Revision of Manuscript Number: IEEE-TPWRS-01391-2021, version 1 February 19, 2022

Journal: IEEE Transactions on Power Systems

Author: Abhishek Halder, Kenneth F. Caluya, Pegah Ojaghi, Xinbo Geng

Response to decision:

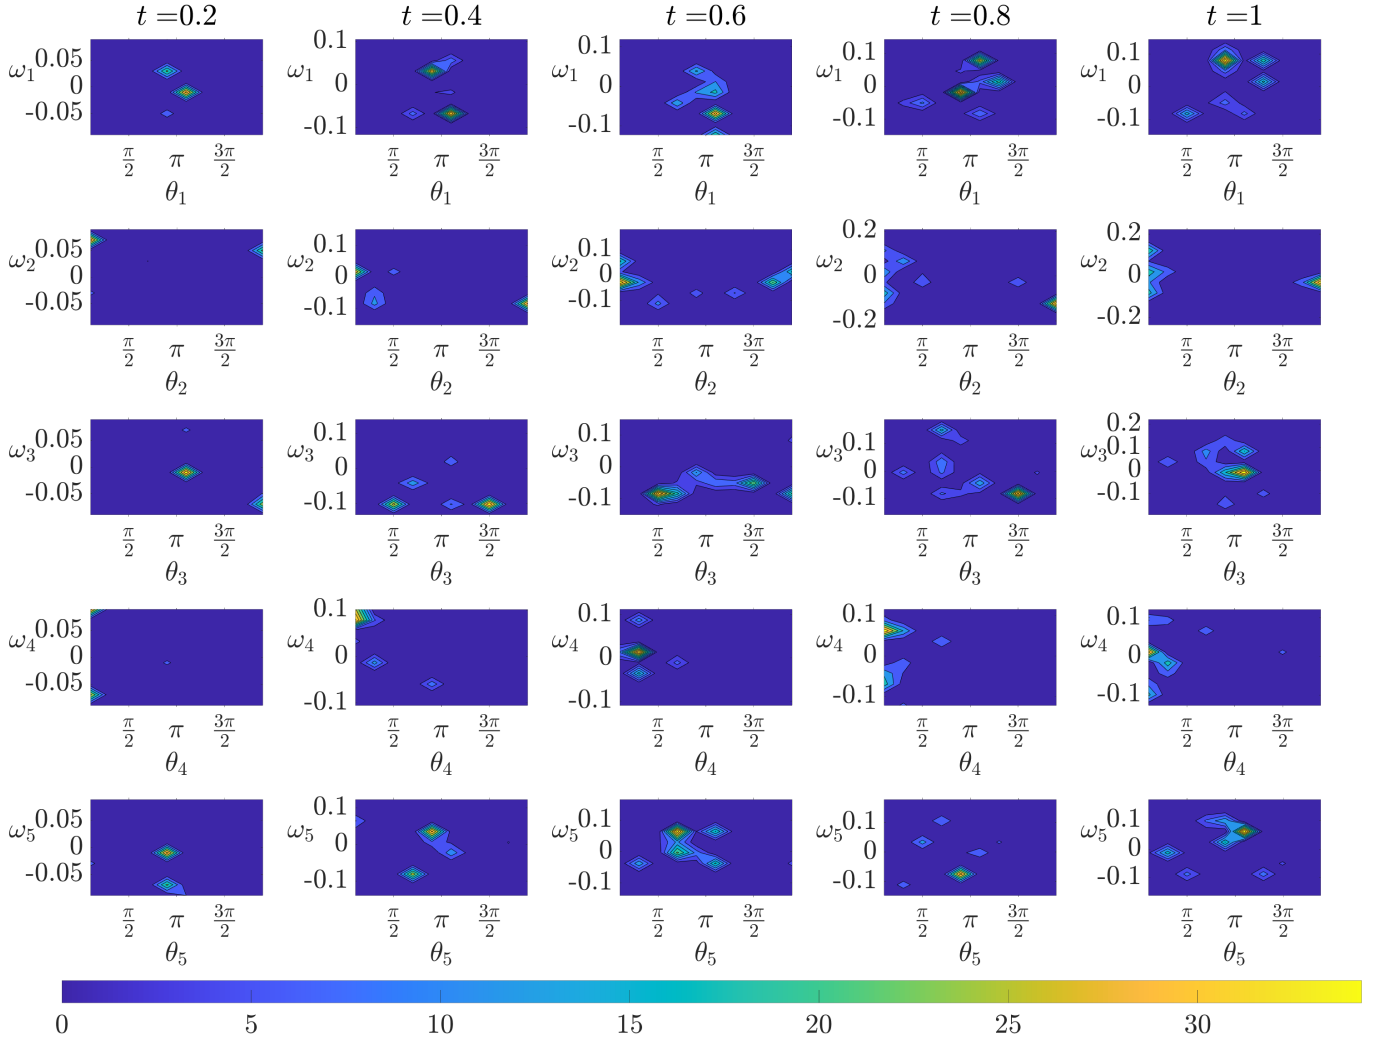
Figures 5 and 6 are unreadable.

Regarding the style of plots, we had considered plotting the bivariate marginals as planar contour plots (as in Fig. 1 in this rebuttal document) but decided against it because of the following two reasons.

Response: Thanks for this comment. In the previous version, the strict 10 page limit enforced small figure sizes. In the revised manuscript, Figures 5 and 6 are made larger. Also, the Fig. 6 in the revised manuscript shows the transient (θ_i, ω_i) bivariate marginals for all the five generators in Case II; the previous version showed the same only for the generator 4 (bus 6). We believe these changes have improved clarity.

First, in our opinion, this kind of plot is scientifically misleading as they hide the fact that these bivariate marginal PDFs are not really supported on the plane, or the subsets thereof, but instead have cylindrical supports. Our message that the proposed method explicitly accounts this manifold geometry in the computation, would be missed had we chosen to make the plots the other way.

Second, the planar contour marginal plots require additional mental efforts from the readers to correctly parse the statistical information conveyed. For instance, consider the fourth column, second row subplot in Fig. 1 in this rebuttal document. It is upon the reader to parse that the two high probability regions on the left and right of that subplot are actually referring to the same angular high probability region around $\theta_2 = 0$ rad, thanks to the periodic boundary condition on the angular variable. Our philosophy of technical communication is that the onus is on the authors, not on the readers, to clarify the scientific information as correctly as possible. We thus prefer to make plots that depict the variables as they are.
